Subject: RE: 200 AldiGordon Kirkby < GKirkby@ethosurban.com>ngton - consultation with NRAR

We have been assisting the Trustee for Fife Kemps Creek Trust with their project at 200 Aldington Road, Kemps Creek. This is a State Significant Development (SSD 10479) for a concept plan comprising 13 development lots, internal roads, bulk earthworks and utilities. The SEARs require consultation with DPIE Water Group including NRAR. Whilst a full riparian assessment will be lodged with the SSD application, this email contains a basic description of the site and the proposed project for the purposes of initial consultation.

Figure 1 Waterfront land

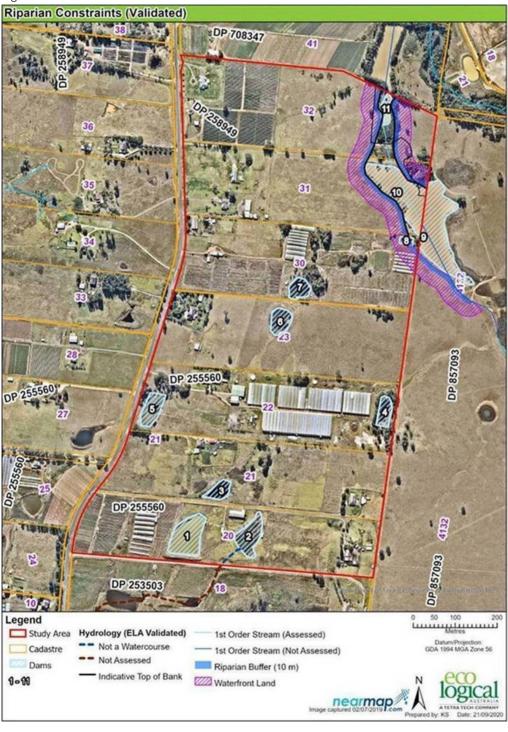
- The mapped watercourse within the subject site was previously assessed by NRAR and it was determined that it was considered to be waterfront land as defined by the Water Management Act 2000. The watercourse present is a 1st order watercourse that enters Ropes Creek downstream which is a 3rd order watercourse.

- The watercourse within the subject site has undergone past modification and will therefore likely need the construction of a post-development channel and establishment of a riparian corridor. The watercourse reconstruction should tie into upstream and downstream sections of the watercourse and not limit any connectivity in the area.

- The information below shows the planned realignment of the watercourse towards the east through an identified wetland area and then into Ropes Creek. Based on the information provided to NRAR, we would not support the realignment of the watercourse as it does not comply with the Mamre Road Precinct Structure Plan June 2020. The project must also assess post-development impacts on the watercourse and the adjacent wetland area.
